PCN #: 2439

PCN Title: Qualification of "Diodes Technology (Cheng Du) Company Limited" (CAT) as an Additional Assembly & Test Site, Using Gold Bond Wire, and as an Additional Wafer Back Grinding and Back Metal Process Source on Select MOSFET Products

**PCN-2439 REV 1**

**PowerDI5060-8L**

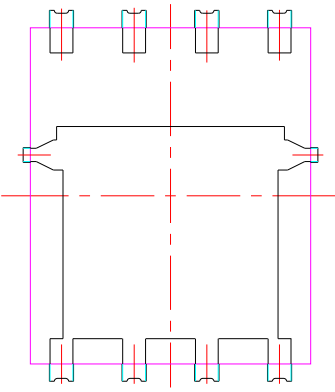
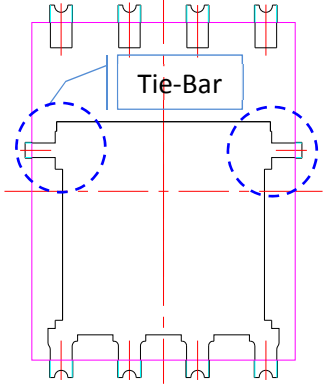
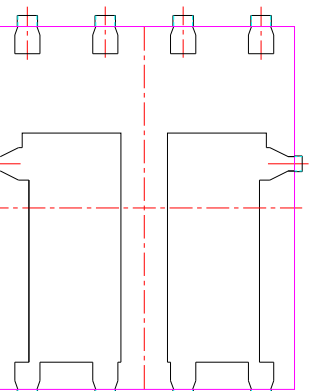
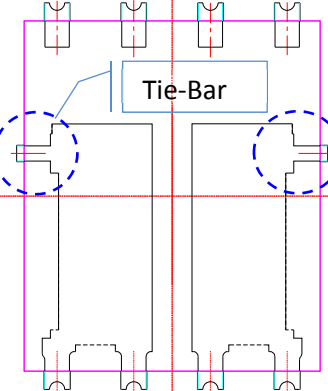
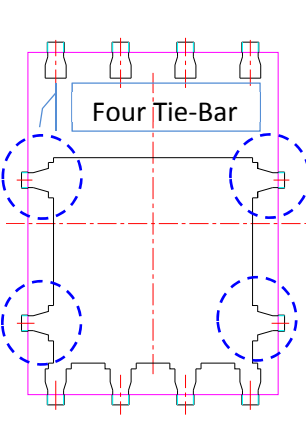
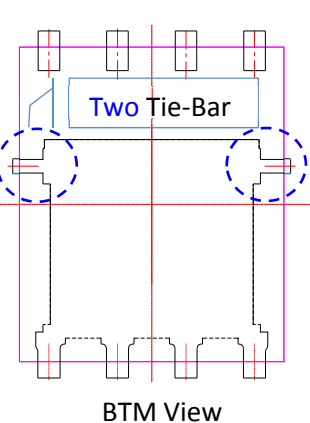
SAT (Current Diodes Internal AT site Shanghai, China)	CAT (Diodes Internal AT Site Chengdu, China) <u>Add bar "-" above Year D/C for CAT site</u>
Marking format example	Marking format example
 <p>DII = Manufacturer's Marking            ABCDEFG = Product Type Marking Code            YYWW = Date Code Marking            YY = Year (ex: 13 = 2013)            WW = Week (01 - 53)</p>	 <p>DII = Manufacturer's Marking            ABCDEFG = Product Type Marking Code  <math>\overline{YY}</math>WW = Date Code Marking  <math>\overline{YY}</math> = Year (ex: 13 = 2013)            WW = Week (01 - 53)</p> <p>Other marking layout also will follow change for site Identifier</p>

**SC-59**

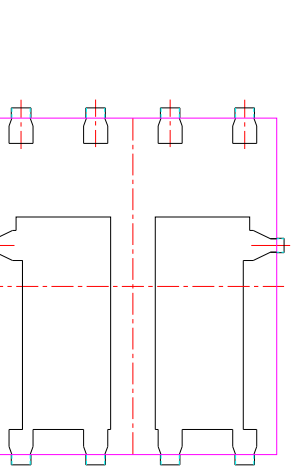
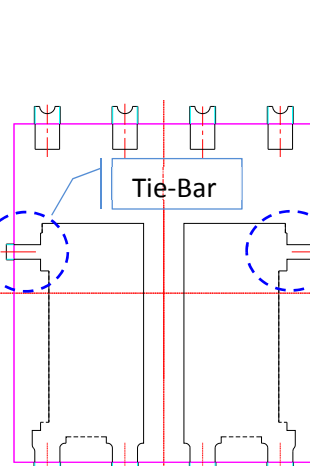
SAT (Current Diodes Internal AT site Shanghai, China)	CAT (Diodes Internal AT Site Chengdu, China) <u>Add bar "-" above Year D/C for CAT site</u>
Marking format example	Marking format example
 <p>N7=Product Type Marking Code            YM=Date Code Marking            Y= Year (ex: A=2013)            M=Month (ex: 9=September)</p>	 <p>N7=Product Type Marking Code            YM&amp;<math>\overline{Y}</math>M=Date Code Marking  <math>\overline{Y}</math>= Year (ex: A=2013)            M=Month (ex: 9=September)</p> <p>Other marking layout also will follow change for site Identifier</p>
